ENSHAM CENTRAL PROJECT

ENVIRONMENTAL IMPACT STATEMENT ADDENDUM

24 October 2006

ENSHAM RESOURCES PTY LTD
Level 18, AMP Place, 10 Eagle Street
BRISBANE QLD 4000

Drawing 4 in EIS Appendix C

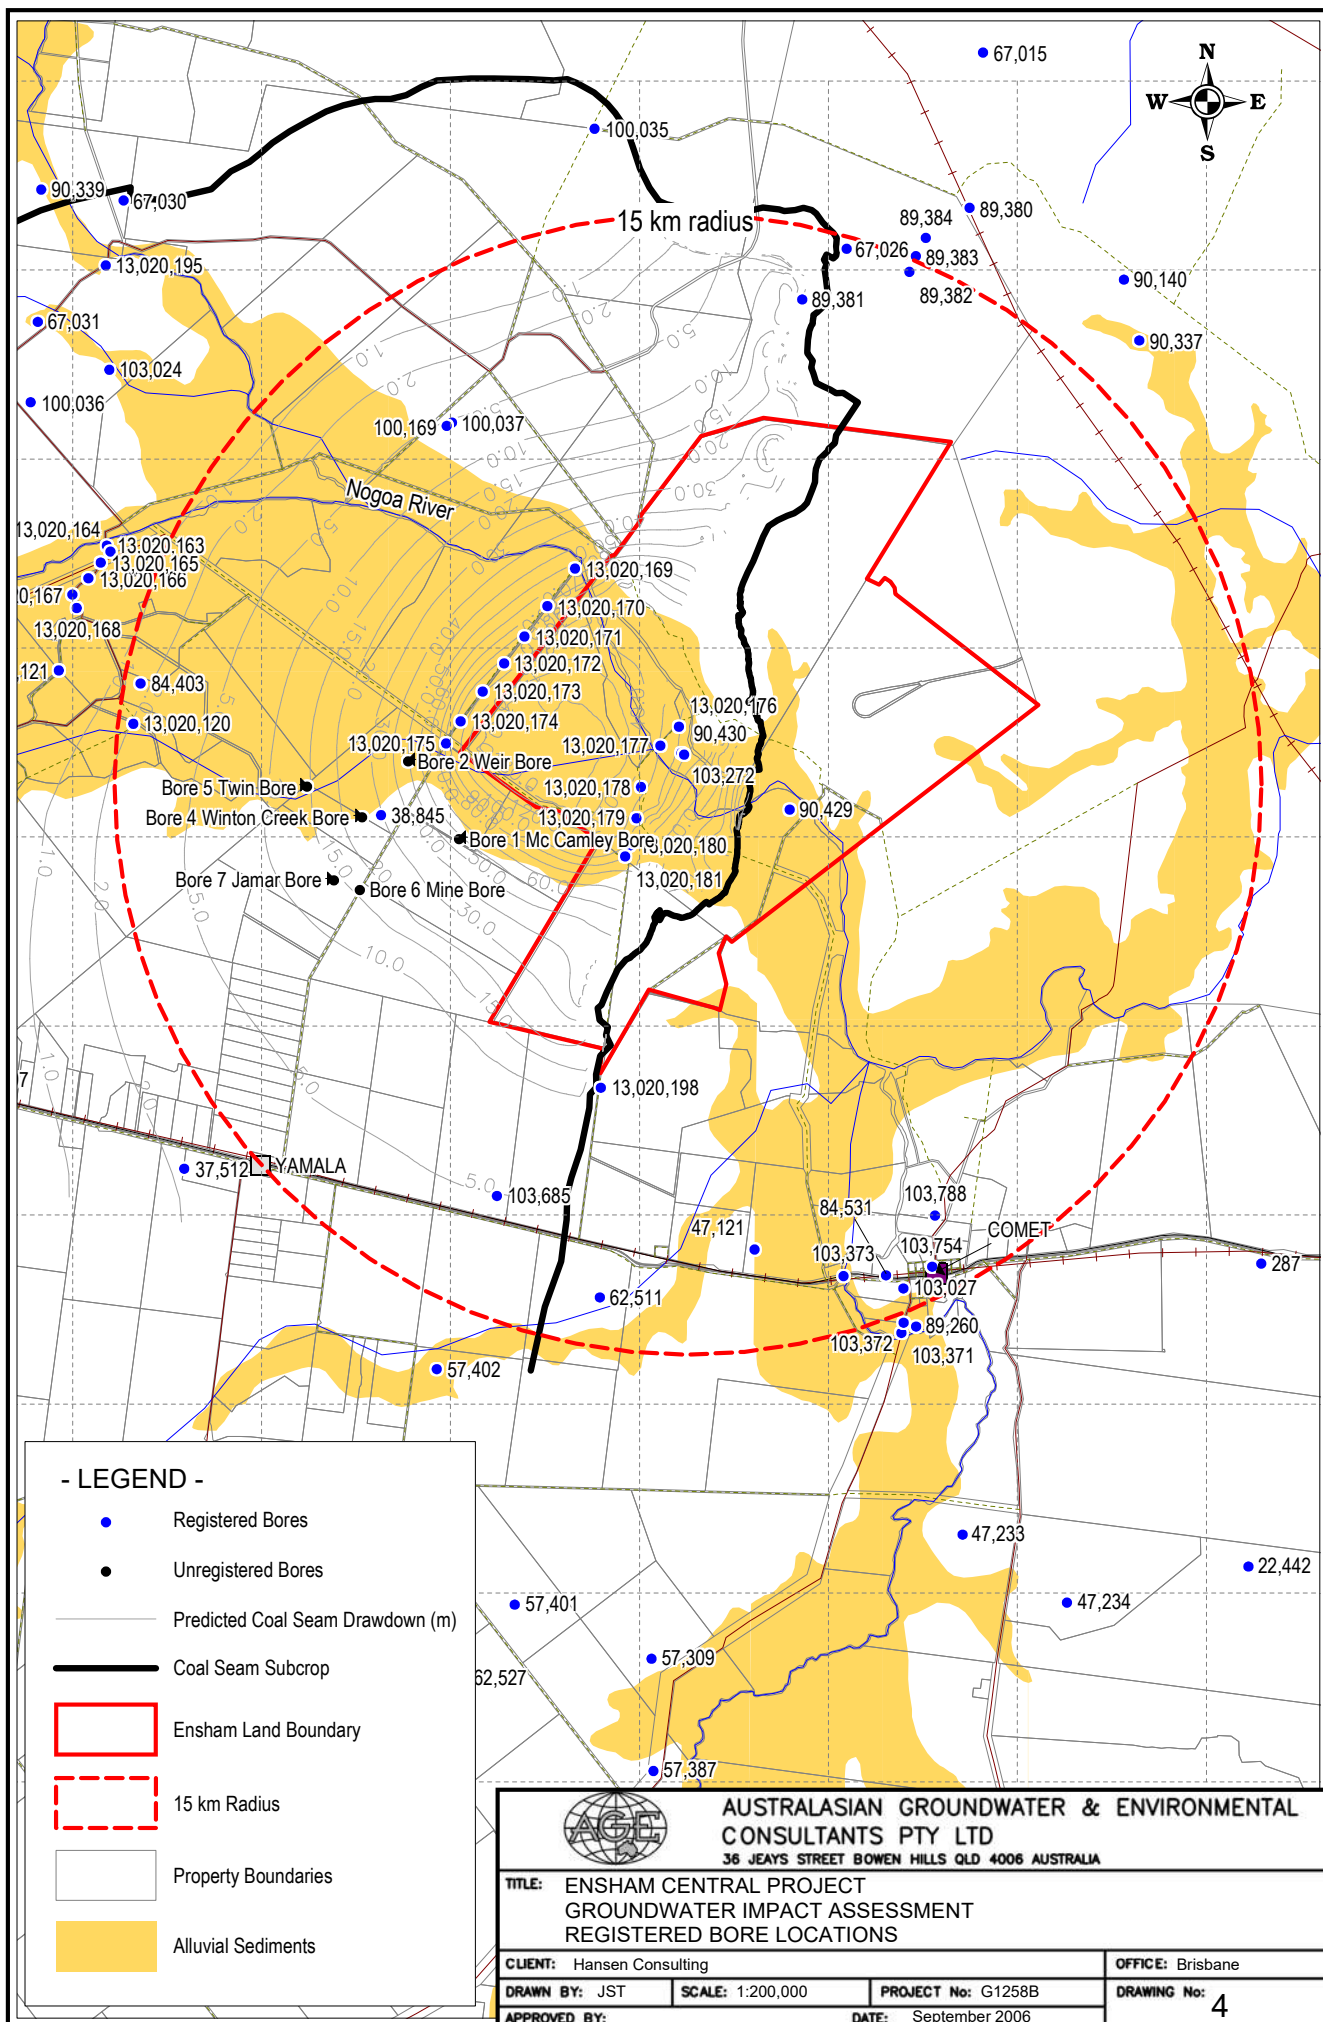
Amended EIS Section	Amendment	Relevant Submission
Drawing 4 – Appendix C	Figure has been amended to show all privately owned bores and the coal seam subcrop.	- Department of Natural Resources, Mines and Water: Issue 9.11. - G.W. & J.E. Little: Issue 17.1. - C.F. & M. L. Vandersee: Issue 18.2.
Appendix F, Section 3 Air Quality Regulations and Goals (first paragraph – after the dot points, page 4).	“... <u>Both the annoyance threshold (concentration) guideline of 0.5 ou and 2.5 ou (1-hour average, 99.5th percentile) is may be of most relevance for this assessment of the Ensham underground mine ventilation shaft, depending on the final design of the ventilation shaft.</u> ”	Environmental Protection Agency: Issue 5.14.
Appendix F, Section 6 Odour Assessment of the Ensham Central Project Ventilation Shaft (first paragraph, page 23).	The Ausplume dispersion model (Version 6) has been used to model odour emissions from the ventilation shaft and to predict ground-level concentrations of odour for comparison with the EPA’s guidelines of 0.5 ou and 2.5 ou (99.5th percentile, 1-hour average). <u>The ventilation shaft has been represented in the following two different ways in the dispersion model because a detailed design is currently not available:</u> <u>A short ventilation shaft with no vertical emission velocity. This configuration is not likely to act like a stack discharge and will be affected by aerodynamic wakes. This configuration was modelled as a volume source and the recommended separation distance was calculated from the EPA’s guideline of 2.5 ou; and</u> <u>A taller ventilation shaft (2 metres above ground level) with low vertical emission velocity and no wake effects. This configuration was modelled as a stack source and the recommended separation distance was calculated from the EPA’s guideline of 0.5 ou.</u>	Environmental Protection Agency: Issue 5.14.

Figures 16.5 & 21.7 in EIS Volume 1
Figure 7.2 of Appendix I

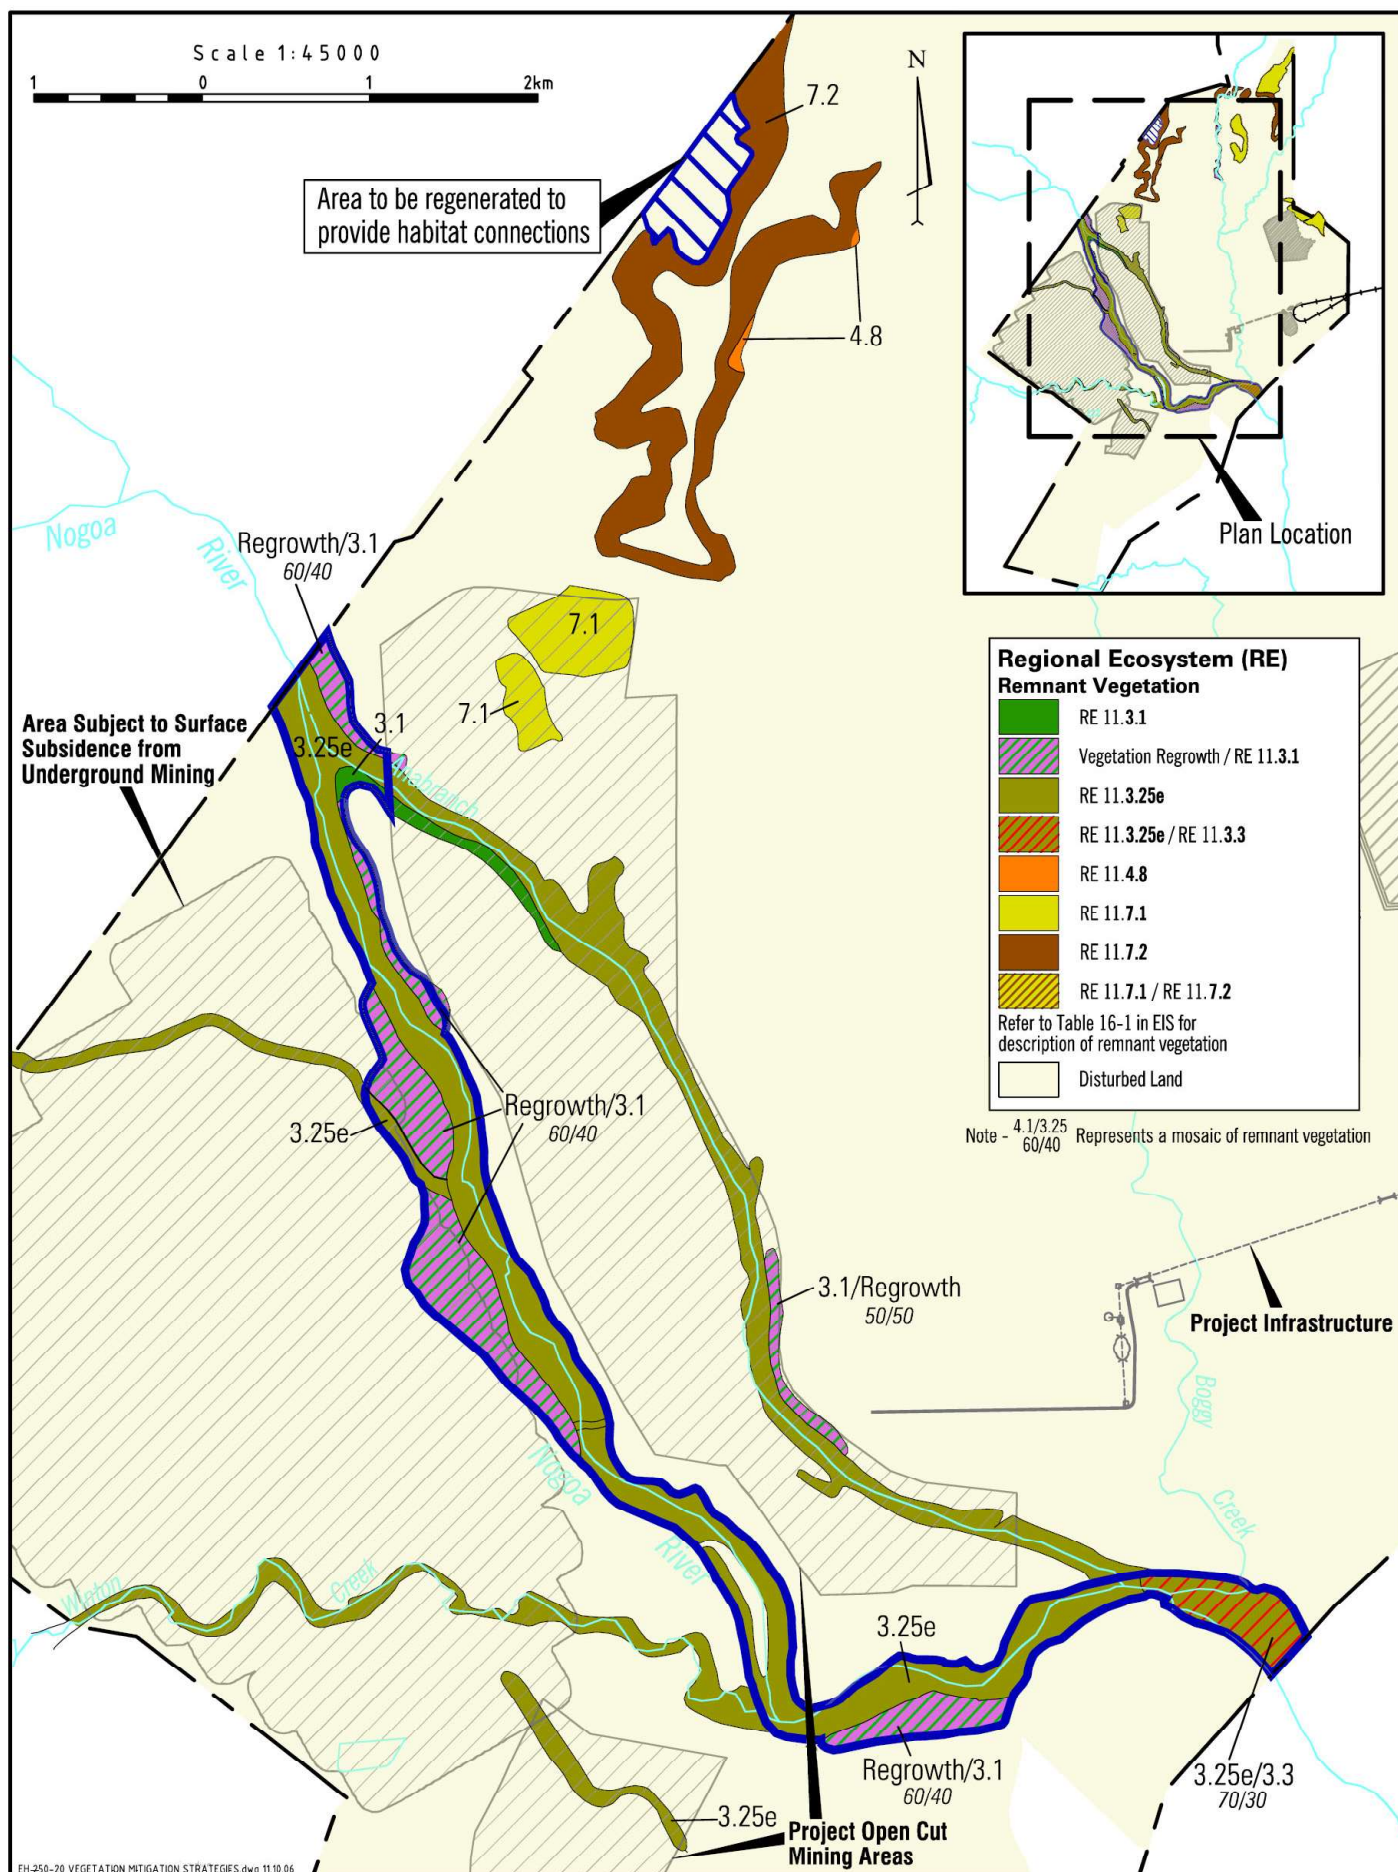
Figure 16.5	Figure has been amended to include the area of Regrowth/RE 3.1 (60/40) on the northern side of the Nogoa River riparian corridor in the Vegetation Management Plan.	Amendment in response to letter from DEH dated 18 August 2006.

Figure 21.7	Figure has been amended to include the area of Regrowth/RE 3.1 (60/40) on the northern side of the Nogoa River riparian corridor in the Nogoa River Vegetation Management Plan.	Amendment in response to letter from DEH dated 18 August 2006.

Figure 7.2 – Appendix I	Figure has been amended to include the area of Regrowth/RE 3.1 (60/40) on the northern side of the Nogoa River riparian corridor in the Nogoa River Vegetation Management Plan.	Amendment in response to letter from DEH dated 18 August 2006.
